Flight Procedures Cover Page	Task Action: FLIGHT CHECK	Task Type: STAR	Estimated Chart Date: 07/11/2024	APWS Task ID: 47C127183A1A423FBC3319E9E1114470	APWS Project ID: 7B846F46AA794ADD8C31971F1E22EEEE0
Procedure: DLAMP (RNAV) EIGHT ARRIVAL		Enroute: YES	Specialist: Johnson, Raymond		Agreement Number:
Airport ID: KSDF			Airport City: LOUISVILLE		State: KY
Facility ID:	Facility Type:	Flight Inspection Remark Type: New FC Slot			
<div>Procedure Comments: PROCEDURE COMPLETED USING ACTIVE AIRNAV AIRPORT DATA. LOA (1): DG/DECEL CONTACT: ALLAN WILL (AJV-A423) - (405) 954-6103. 05/14/2024. THIS IS AN UPDATED COPY OF THE FORM DEVELOPED ON 3/28/24. 8260-2 FILE BRELL, CURRT, QARRY FIX TYPE ACTION, CHANGED FROM NO CHANGE TO CANCEL. 06/05/24: THIS IS A CORRECTED COPY OF THE FORM APPROVED ON 05/14/24. 8260-2_FILE ZOPOM 1.FIX MAKE-UP FACILITIES: ADDED FAC 1 - CORRECT ADMINISTRATIVE ERROR. 2.ADDED ENROUTE V5 TO FIX USE - CORRECT ADMINISTRATIVE ERROR.</div> <div><div>QUALITY 38 CHECKED</div><div>QUALITY 35 CHECKED</div></div>

FIPC DME/DME FORM						
PROCEDURE: STAR DLAMP EIGHT (RNAV) LOUISVILLE KY KSDF			AIRPORT NAME: LOUISVILLE MUHAMMAD ALI INTL		AIRPORT ID: KSDF	SPECIAL CONTROL NO: AG-04-029-24

ARRIVAL ROUTE DESCRIPTION

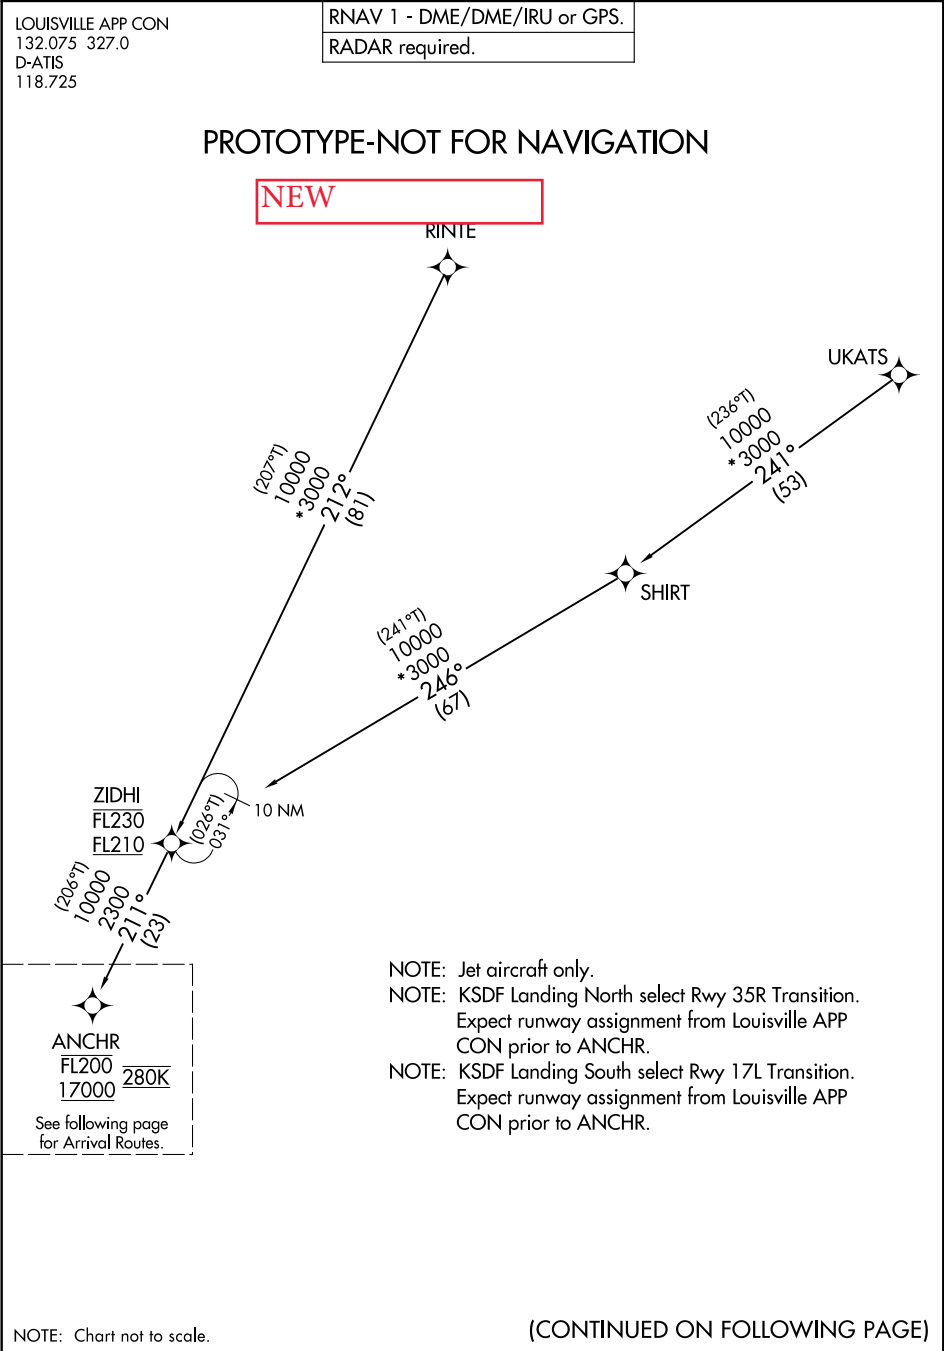
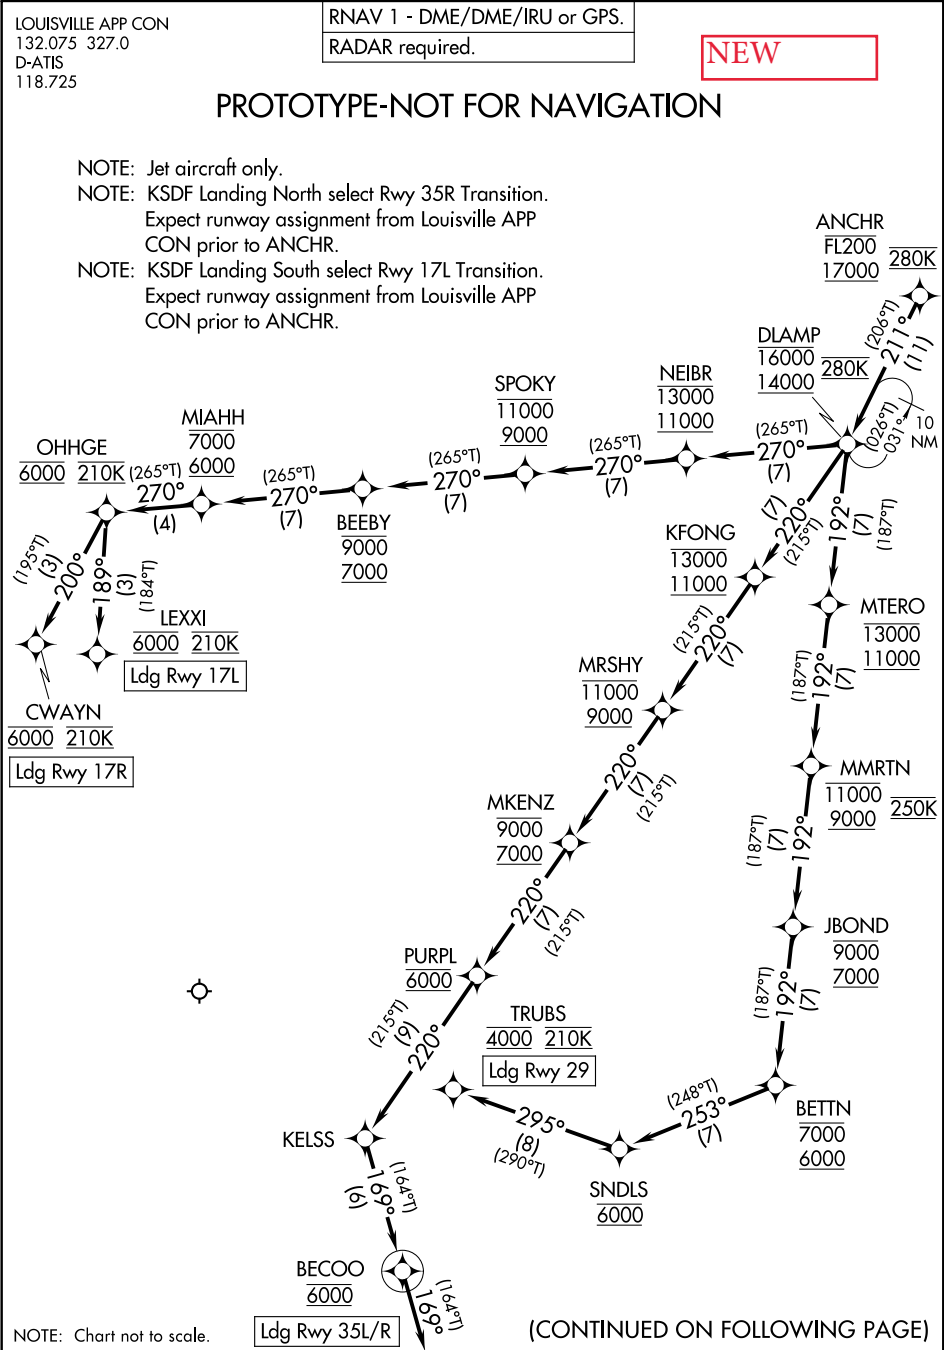
OLD

CINCINNATI TRANSITION (CVG.DLAMP6):
MALDN TRANSITION (MALDN.DLAMP6):
UKATS TRANSITION (UKATS.DLAMP6):

From WARSA on track 222° to NERVE, then on track 222° to RDSTN, then on track 222° to HAYGA, then on track 222° to ZOPOM, then on track 260° to DLAMP, then on assigned runway transition.

LANDING RWYS 17L/R: From DLAMP on track 350° to CURRT, then on track 350°. Expect radar vectors to final approach course.

LANDING RWY 29: From DLAMP on track 170° to BRELL, then on track 171°. Expect radar vectors to final approach course after RDSTN.

LANDING RWYS 35L/R: From DLAMP on track 170° to BRELL, then on track 171°. Expect radar vectors to final approach course.

NEW

RINTE TRANSITION (RINTE.DLAMP8):
UKATS TRANSITION (UKATS.DLAMP8):

From ANCHR on track 211° to cross DLAMP between 14000 and 16000 and at 280K.

LANDING RUNWAY 17L: From DLAMP on track 270° to cross NEIBR between 11000 and 13000, then on track 270° to cross SPOKY between 9000 and 11000, then on track 270° to cross BEEBY between 7000 and 9000, then on track 270° to cross MIAHH between 6000 and 7000, then on track 270° to cross OHHGE at 6000 and at 210K, then on track 189° to cross LEXXI at 6000 and at 210K. Expect ILS or LOC Rwy 17L approach.

LANDING RUNWAY 17R: From DLAMP on track 270° to cross NEIBR between 11000 and 13000, then on track 270° to cross SPOKY between 9000 and 11000, then on track 270° to cross BEEBY between 7000 and 9000, then on track 270° to cross MIAHH between 6000 and 7000, then on track 270° to cross OHHGE at 6000 and at 210K, then on track 200° to cross CWAYN at 6000 and at 210K. Expect ILS or LOC Rwy 17R approach.

LANDING RUNWAY 29: From DLAMP on track 192° to cross MTERO between 11000 and 13000, then on track 192° to cross MMRTN between 9000 and 11000 and at 250K, then on track 192° to cross JBOND between 7000 and 9000, then on track 192° to cross BETTN between 6000 and 7000, then on track 253° to cross SNDLS at 6000, then on track 295° to cross TRUBS at 4000 and at 210K. Expect LOC Rwy 29 approach.

LANDING RUNWAYS 35L/R: From DLAMP on track 220° to cross KFONG between 11000 and 13000, then on track 220° to cross MRSHY between 9000 and 11000, then on track 220° to cross MKENZ between 7000 and 9000, then on track 220° to cross PURPL at 6000, then on track 220° to KELSS, then on track 169° to cross BECOO at 6000, then on track 169°. Expect radar vectors to final approach course.
